DEVELOPMENT APPLIVATION ASSESSMENT REPORT

Application Number:	DA2019/1420
---------------------	-------------

Responsible Officer:	Nicholas England
Land to be developed (Address):	Lot 1 DP 601101
	8 Wyatt Avenue, Belrose
Proposed Development: Alterations and additions to existing school (Jo Colet School) as part of Staged Development consent for new classrooms and ancillary wor staged increase in student numbers at John C School	
Locality:	C8 Belrose North
Category:	Category 3
Development Permissible:	Yes
Existing Use Rights:	No
Consent Authority:	Northern Beaches Council
Delegation Level:	NBLPP
Land and Environment Court	No
Action:	
Owner:	John Colet Schools Inc.
Applicant:	Templum Design Architects

West Elevation:

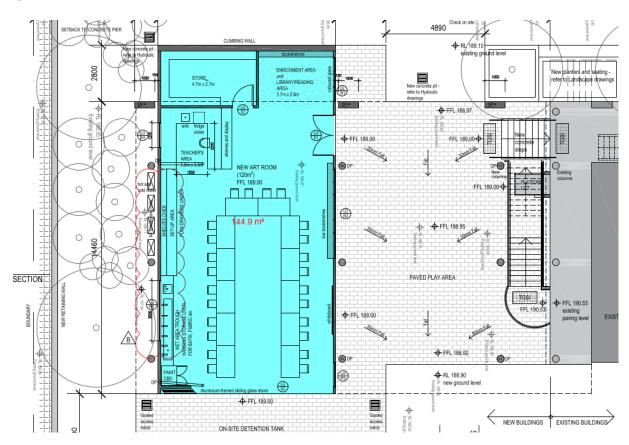
The proposal was amended, via plans received by Council on 21 April 2020. The plans were amended to include an additional window on the west elevation of the ground floor art room. The amendments were re-notified.
